# COMBINED LINWOOD/EASTERN INTERCHANGE & US 50/RED BANK INTERCHANGE FOCUS AREA ADVISORY COMMITTEE MEETING NOTES

EASTERN CORRIDOR SEGMENTS II AND III (PID 86462)

## MEETING #3 NOTES

Sept. 7, 2018

**Figure X-2B-2**  
**GRADE SEPARATED INTERCHANGE TO CONNECT**  
**WILMER AVENUE TO WOOSTER ROAD**

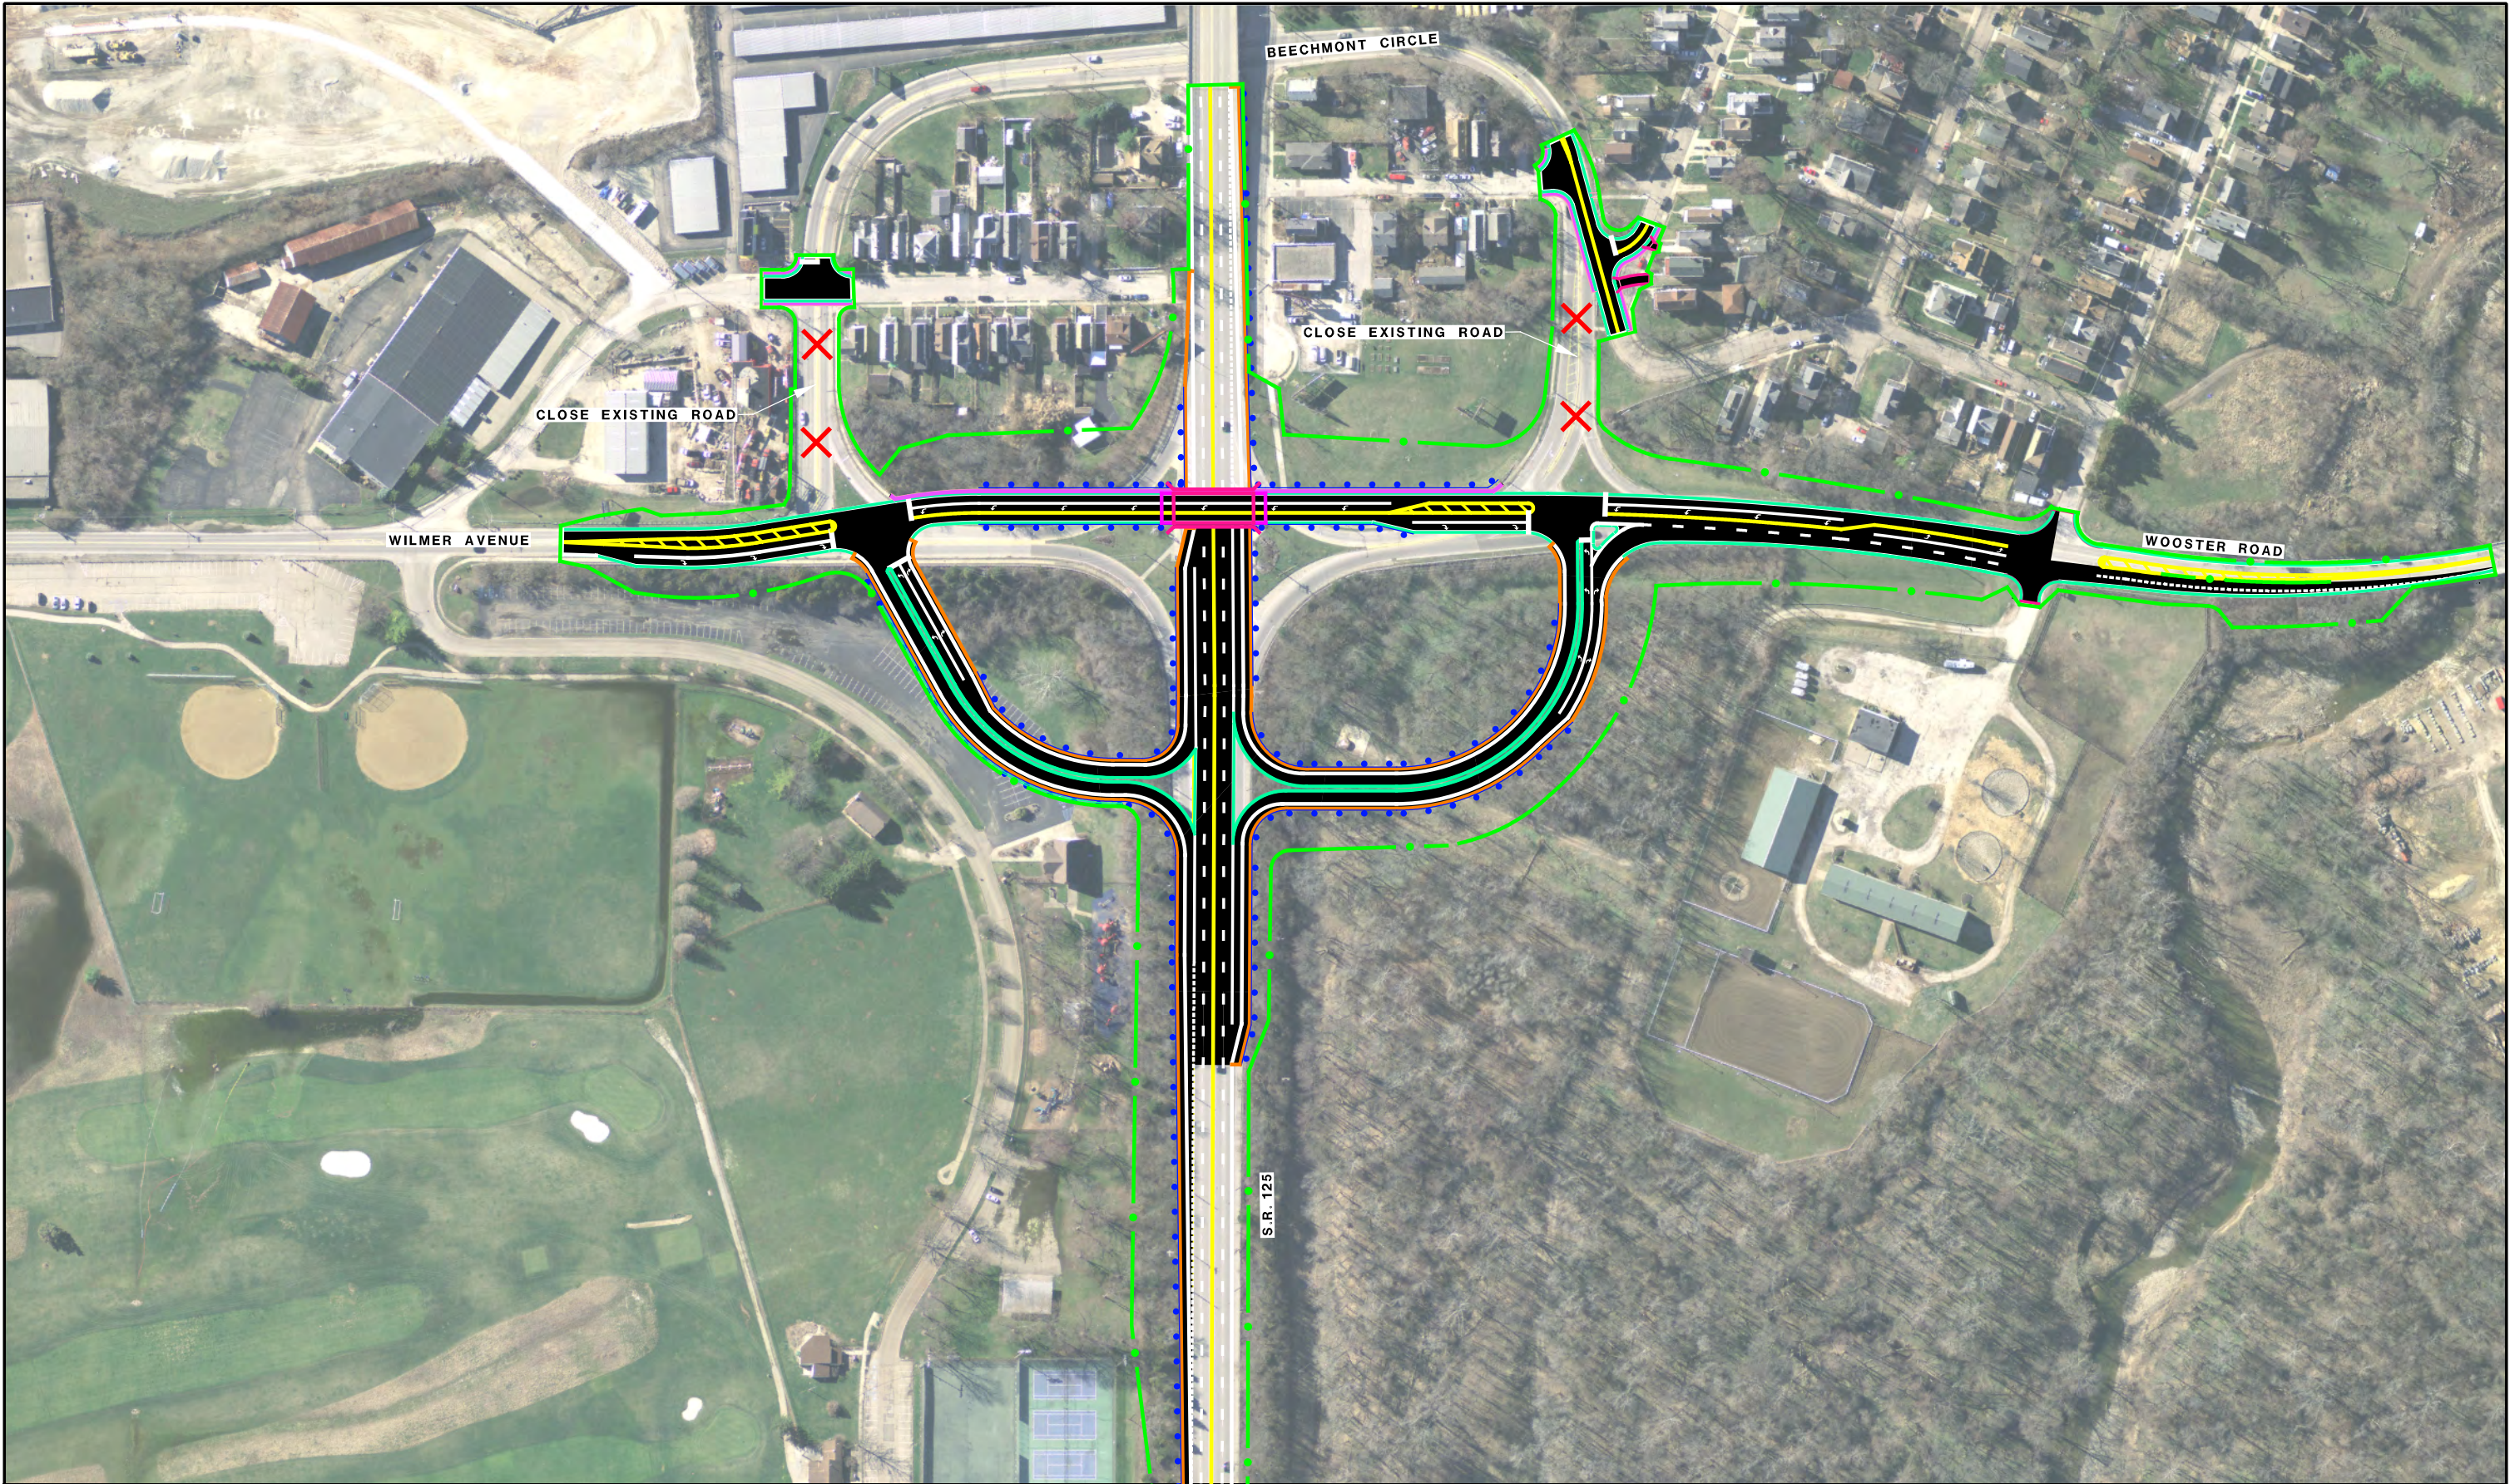
- This concept offers a lower speed connection to Wilmer Avenue and Wooster as compared to concept X-2b-3.
- The Wooster/Wilmer interchange would bridge over over SR 125.
- Offers a clear connection between Wilmer and Wooster.
- Concept would take through-traffic off Beechmont Circle; streets within Beechmont Circle would be used for local traffic.
- Would need to add a turn lane to Hutton Street from Wooster.
- Concept would impact the locations of existing bus stops; bus stops would have to be relocated.

- Will the three-way intersections on either side (East and West) of the proposed grade change connection of Wilmer and Wooster be signalized, or stop signs? Concern this will slow flow of traffic compared to current design.

- This alternative should be evaluated with X-2b-2a and X-2b-5.
- The concept connects Wooster and Wilmer over SR 125. Wooster and Wilmer would connect with SR 125 using T-intersections (although the Wilmer/SR 125 connection may have to be adjusted somewhat).
- This option would pull commuter traffic out of two small subdivisions. (the Linwood Neighborhood Plan identifies removing commuter traffic from the neighborhood as a goal).
- This concept would result in the loss of parking spaces in the Lunken Playfield parking lot, though the number of spaces lost is not yet known.

- Advance for public consideration.

### Figure X-2B-2A

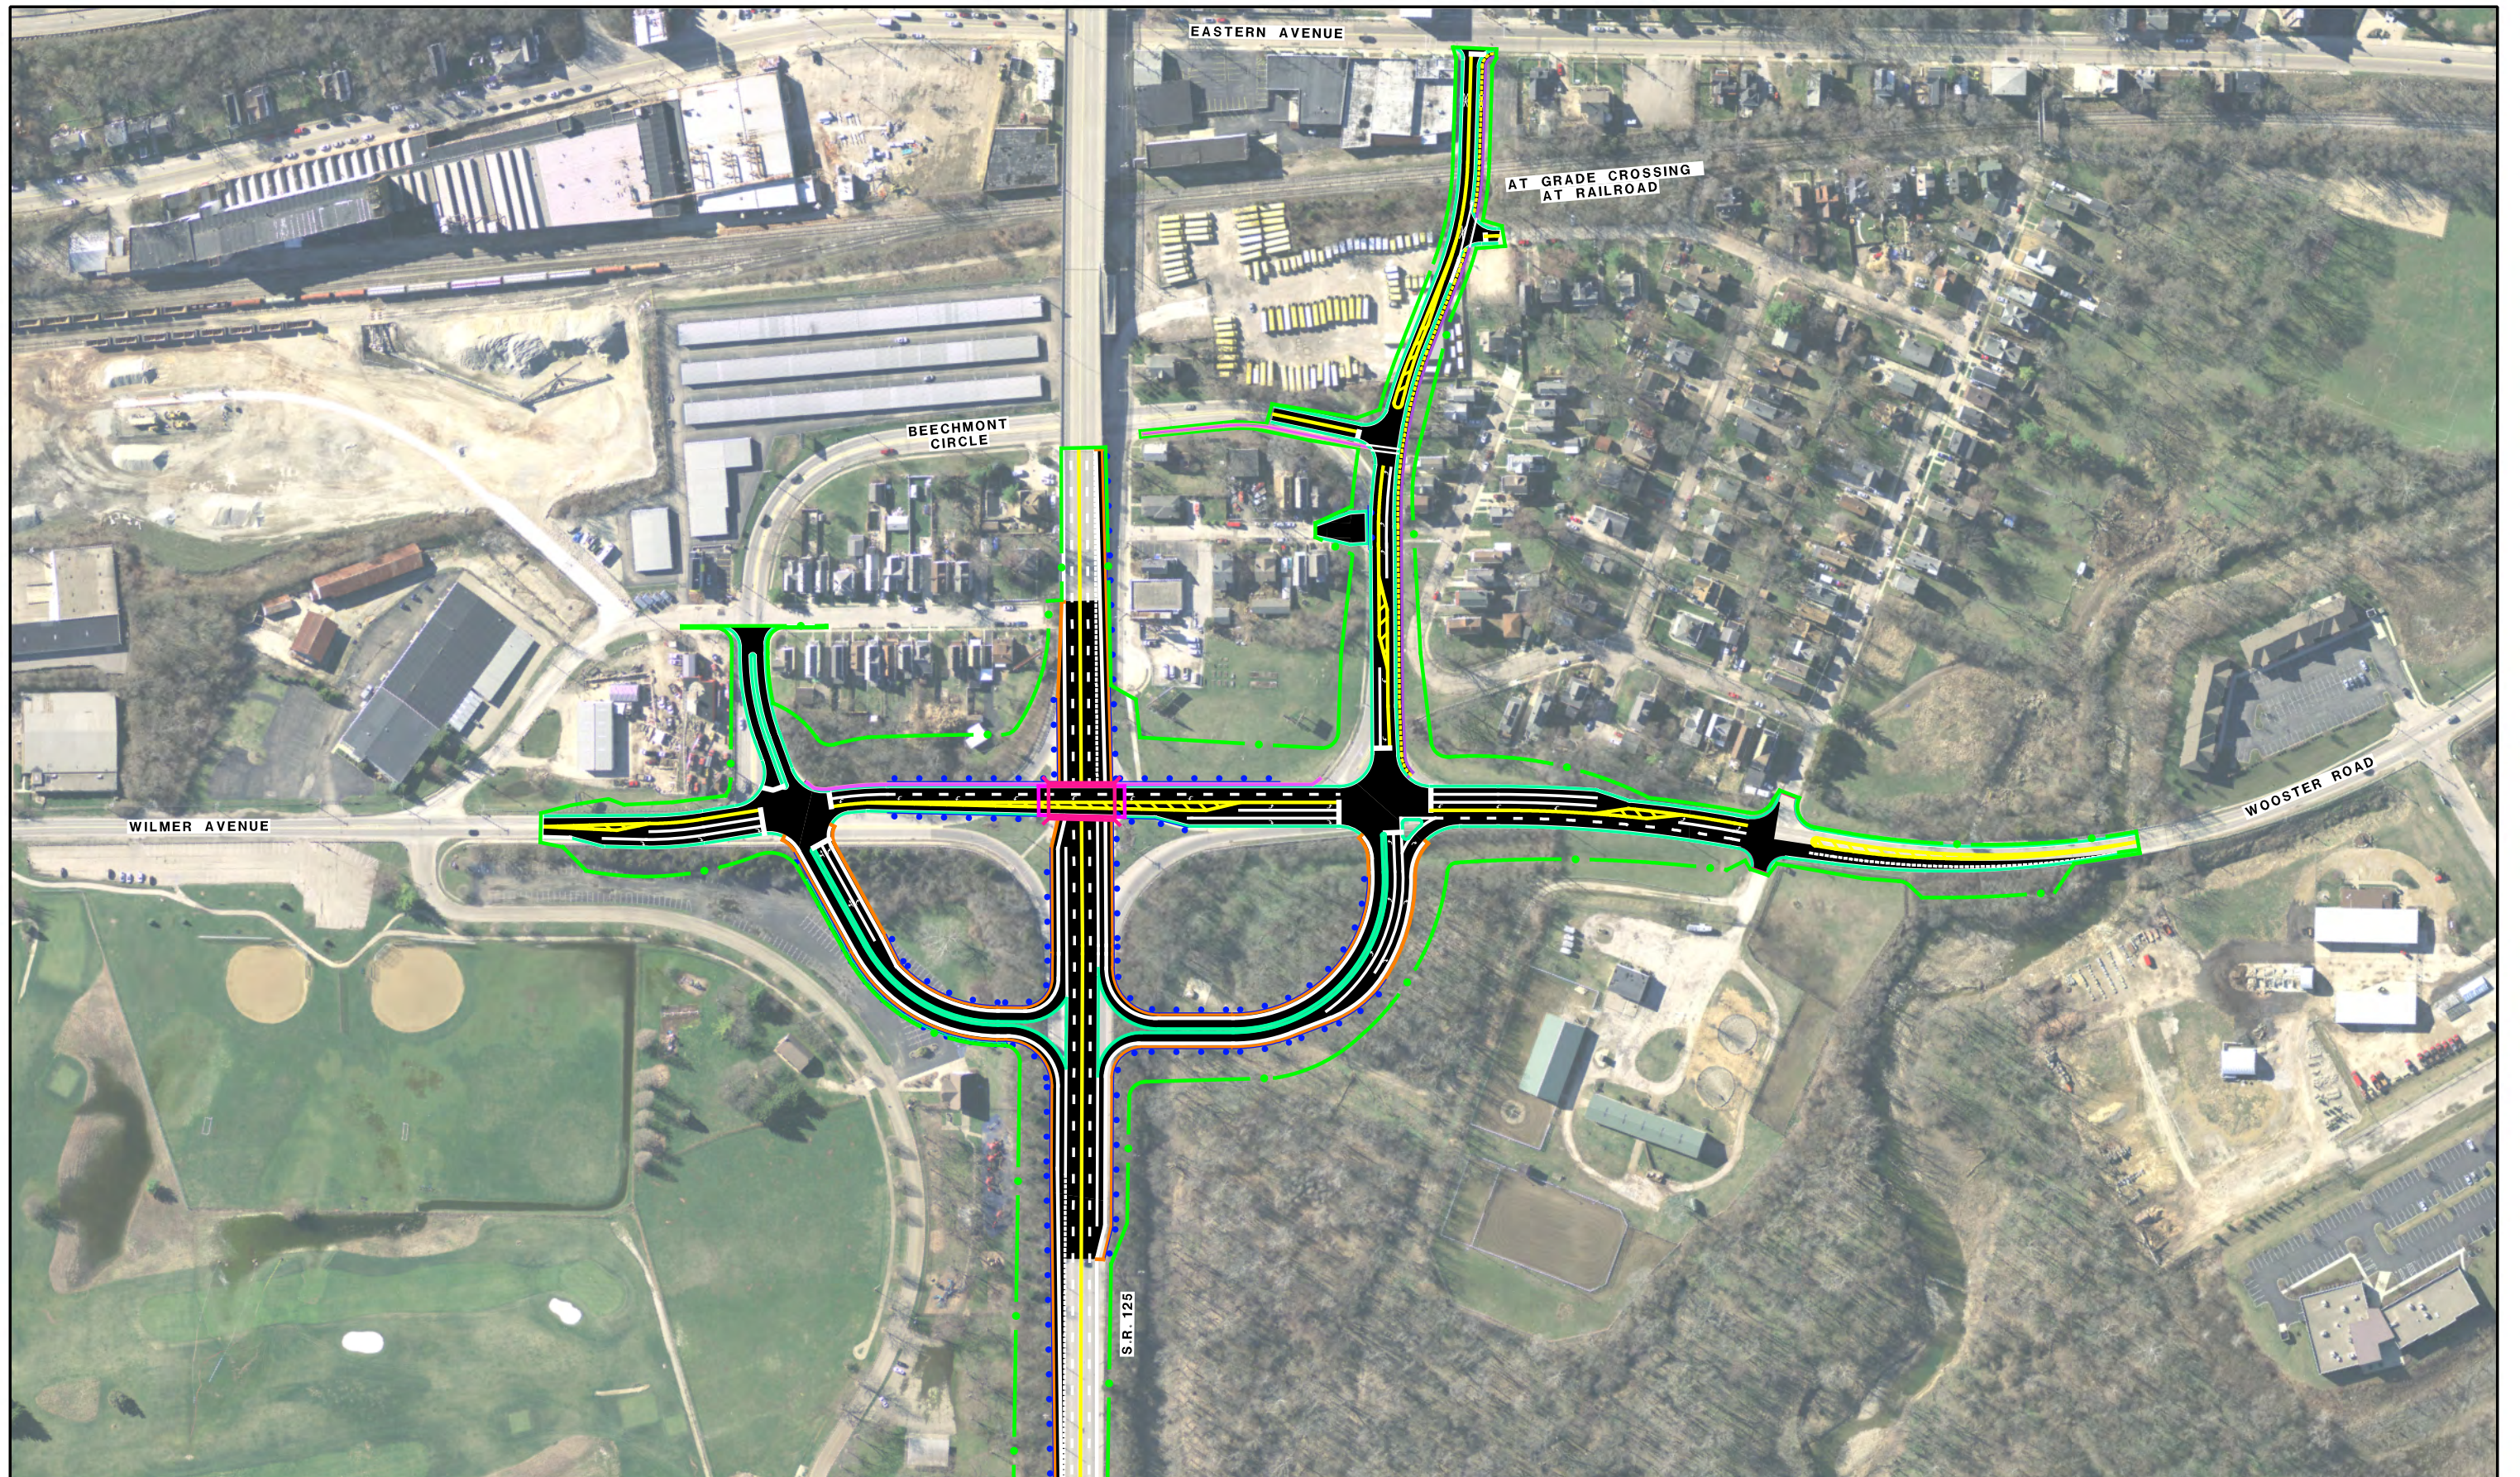
- The two subdivisions within Beechmont Circle remain separated; however most commuter traffic would be removed from neighborhood streets (the Linwood Neighborhood Plan identifies removing commuter traffic from the neighborhood as a goal).

- Advance for public consideration.
